APPLICATION AND
FINAL PLAT CHECKLIST

Name of Proposed Subdivision CHANDLERS LANDING - PHASE 15

Name of Proposed Development: Chandlers Landing, Phase 15

Re: Chandlers Landing
Phase 15

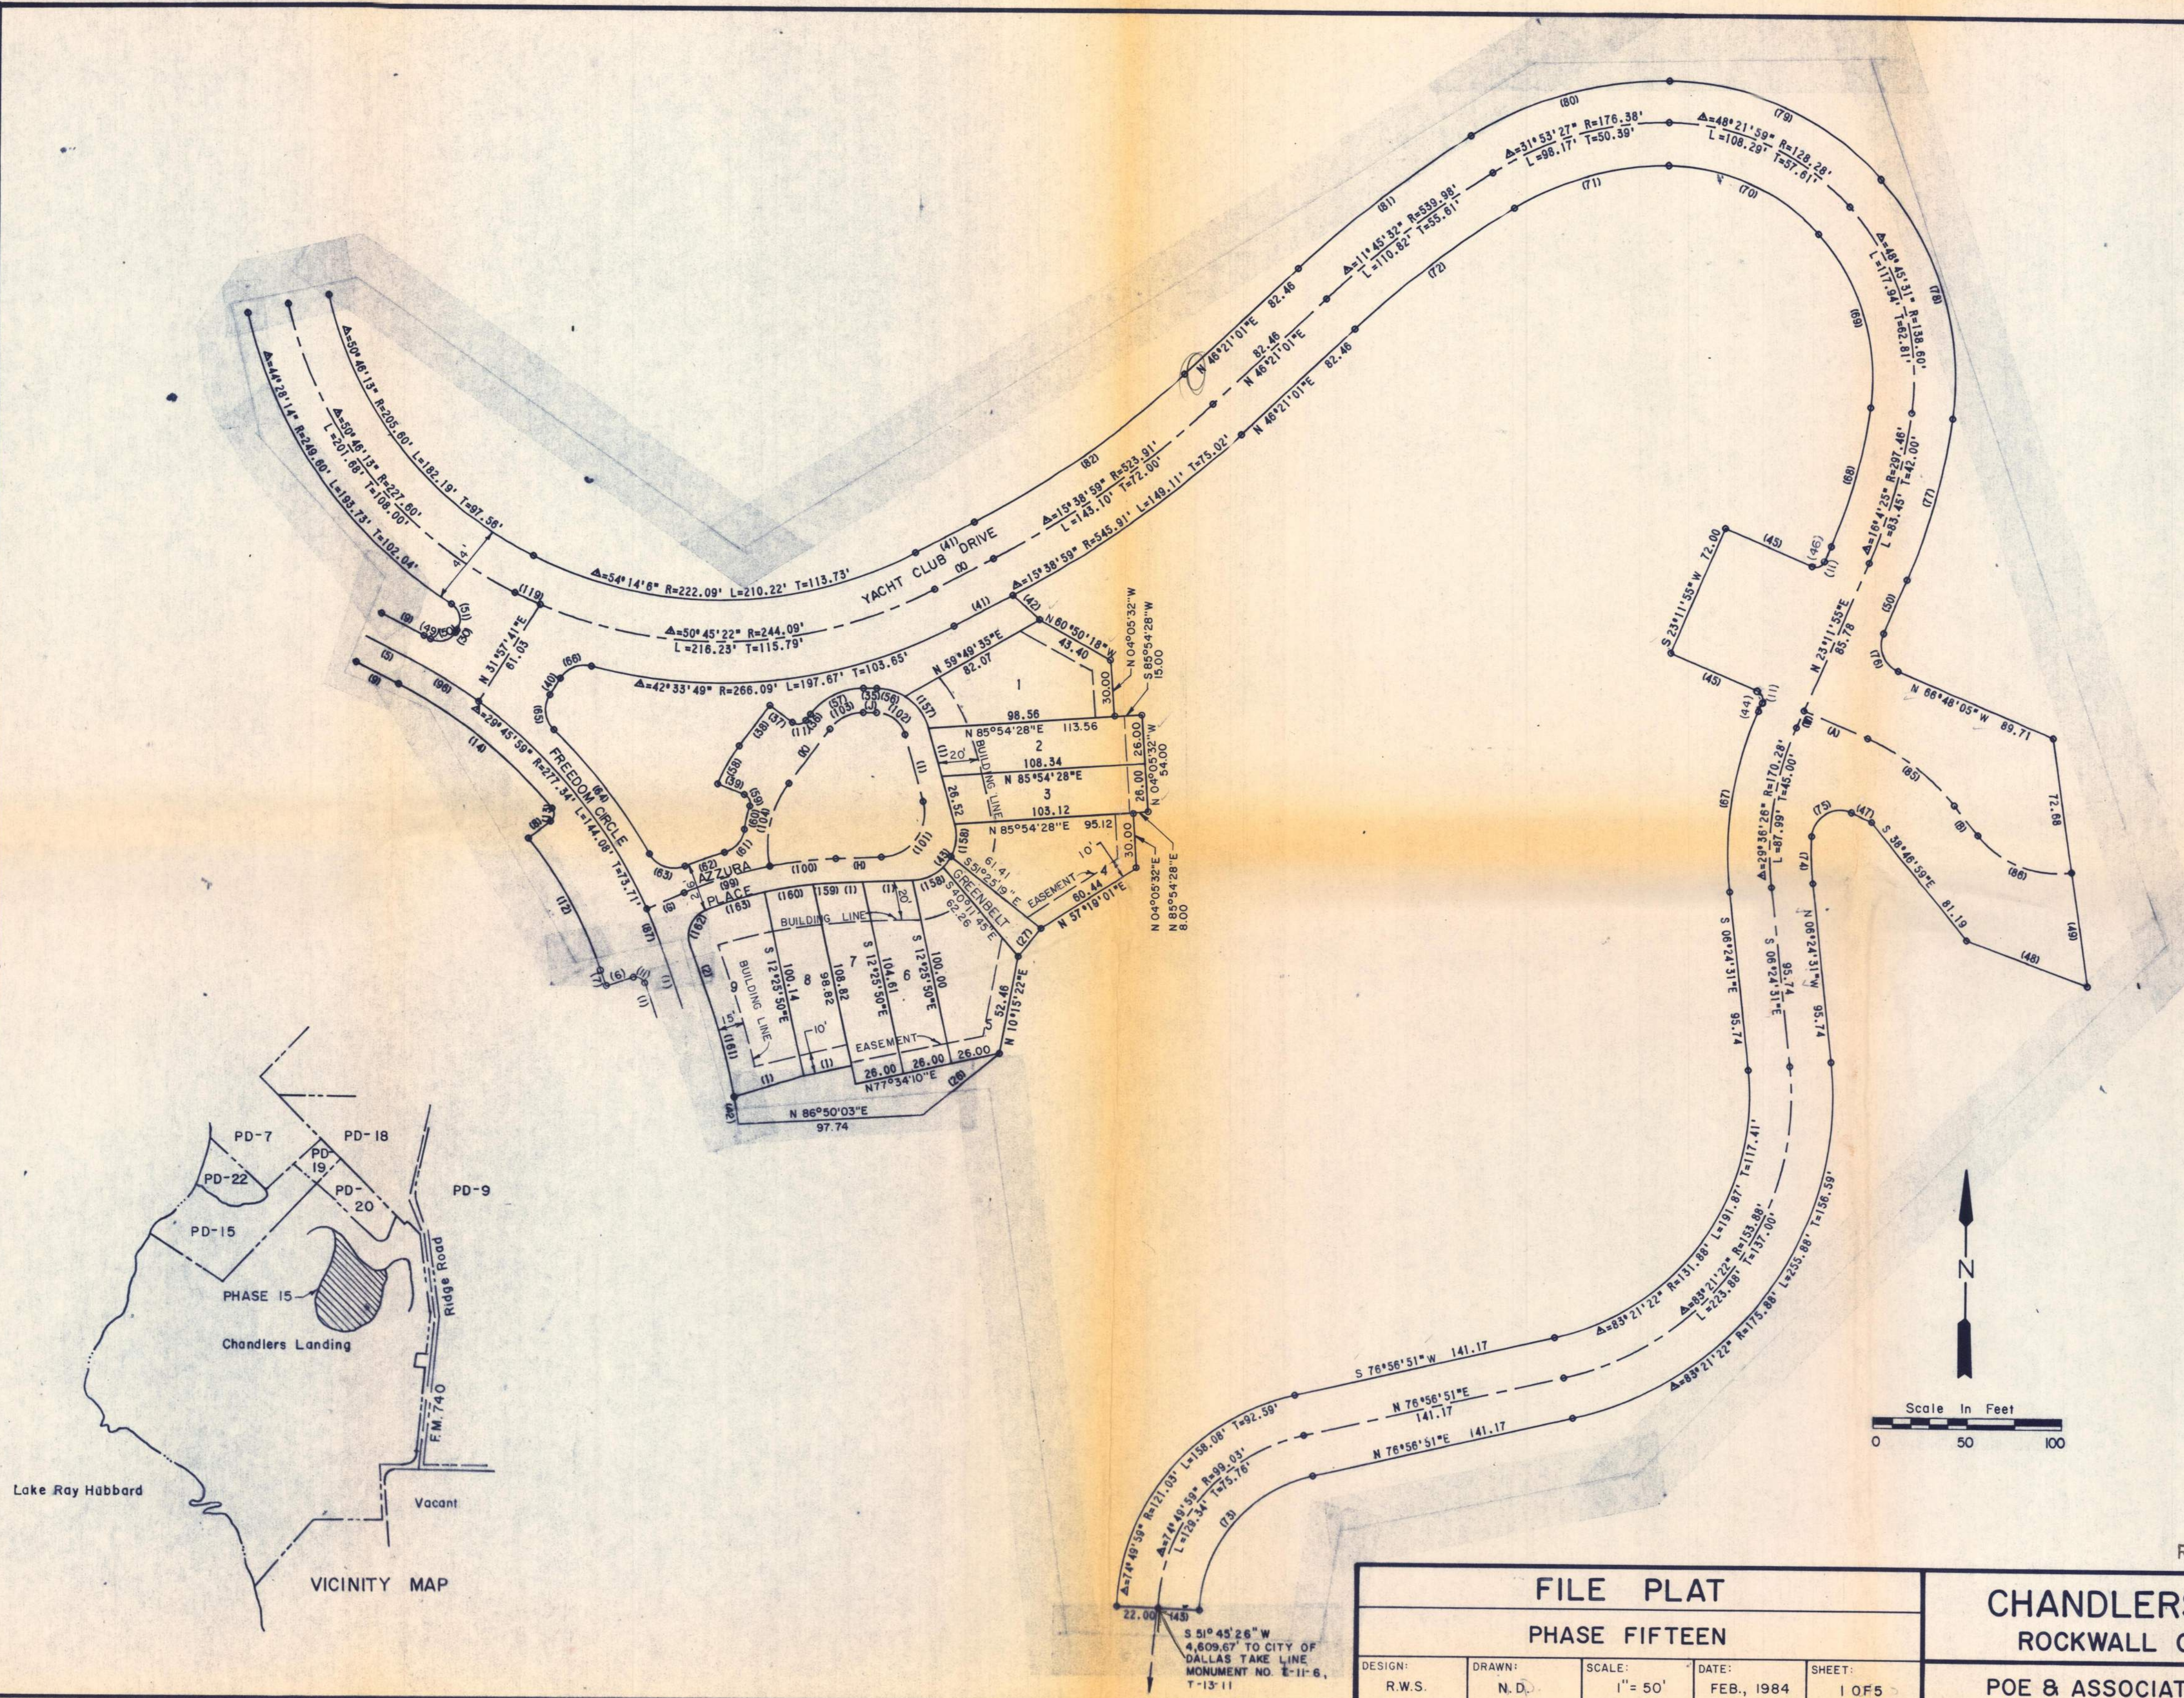
1. Width of Yacht Club Drive
2. Put lot frontages on plat drawings
3. Block letters on first page
4. Defender Court 26 ft.
5. Label Block A more often
6. Minimum lot area townhouse lots -
3000 sq. ft. (example - lots 2,6,7 Block B)
7. Lot 31, Block A depth not 100 ft.
8. Point of Beginning
9. City of Rockwall signatures, not County
10. City will not put easement back to original state
11. Swim park on plat?

3/8/84 - Approval subject o engineering and Staff comments.

4/2/84 - Approve subject to engineering, 36 ft. Yacht Club Drive north of new entrance with no lots facing and designated as fire lane enforced by Chandlers Landing, lot frontages on drawing, Defender Ct. 26 ft., all lots meet minimum depth and area requirements, and point of beginning.
